Access Compliance Report

Public Rights-of-Way

(Curb Ramps)

Intersection ID: 29352	Main Street: OSAGE_CR	Cross Street: OSAGE_CR	Location: SW
ADA ID: B012E89845DF	Ramp Type: PerpDiag	Initial Pass/Fail: Fail	Overall Compliance: No
Severity Score: 8.75			
Codes/Mitigation Info/Possible Solution		Field Measurements/Component Compliance

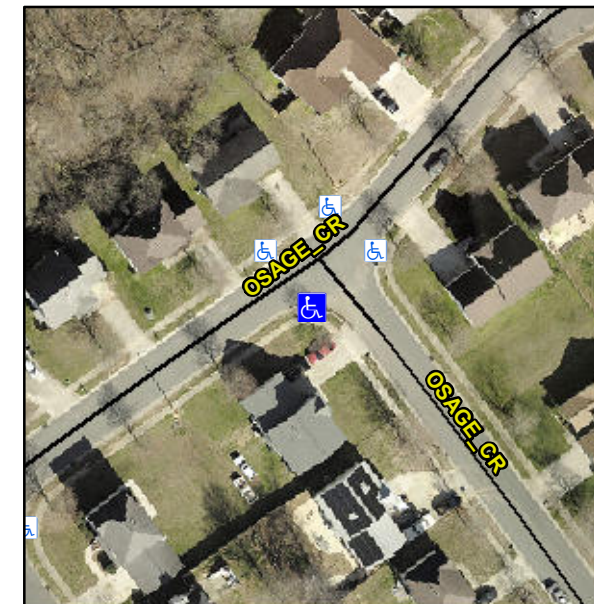
Not Found, R304.5.1

Compliance	Description	Data	Compliance	Description	Data
N/A	Ramp Length (in)	49.0	Yes	Ramp Slope (%)	6.0
No	Ramp Width (in)	44.0	Yes	Ramp XSlope (%)	2.0
N/A	Flare Type LT	N/A	N/A	Flare Type RT	N/A
N/A	Flare Slope LT (%)	N/A	N/A	Flare Slope RT (%)	N/A
N/A	Flare Traversable LT?	N/A	N/A	Flare Traversable RT?	N/A
N/A	Landing Length (in)	N/A	N/A	DWS Provided?	N/A
N/A	Landing Width (in)	N/A	N/A	DWS Contrast?	N/A
N/A	Landing Slope (%)	N/A	N/A	DWS Length (in)	N/A
N/A	Landing X Slope (%)	N/A	N/A	DWS Full Width?	N/A
N/A	Landing Curb? (Y/N)	N/A	N/A	DWS Offset (in)	N/A
N/A	Shared Landing?	N/A			
N/A	Gutter Ponding?	N/A	N/A	Gutter Slope (%)	N/A
N/A	Gutter Lip Ht (in)	1.0	N/A	Gutter X Slope (%)	N/A
N/A	Painted X Walk1?	No	N/A	Painted X Walk2?	No
	X Walk 1 Direction	To NE		X Walk 2 Direction	To NW
N/A	X Walk 1 Width (in)	N/A	N/A	X Walk 2 Width (in)	N/A
	X Walk 1 Slope (%)	0.2		X Walk 2 Slope (%)	2.3
	X Walk 1 X Slope (%)	1.3		X Walk 2 X Slope (%)	0.9

N/A	Ramp inside XWalk1?	N/A	N/A	Ramp inside XWalk2?	N/A
	Road Slope (%)	2.2	N/A	Clear Space?	N/A
	Road X Slope (%)	5.3	N/A	Clear Space to XWalk (in)	N/A
N/A	Any Obstructions?	N/A	N/A	Storm Grate/Utility Hazard?	N/A
	Obstruction Type			Storm Grate/Utility Type	
		N/A			N/A
			Yes	Surface Condition? (G/P)	Good

Remove & Replace Curb Ramp With Two New Directional Ramps or Equivalent.
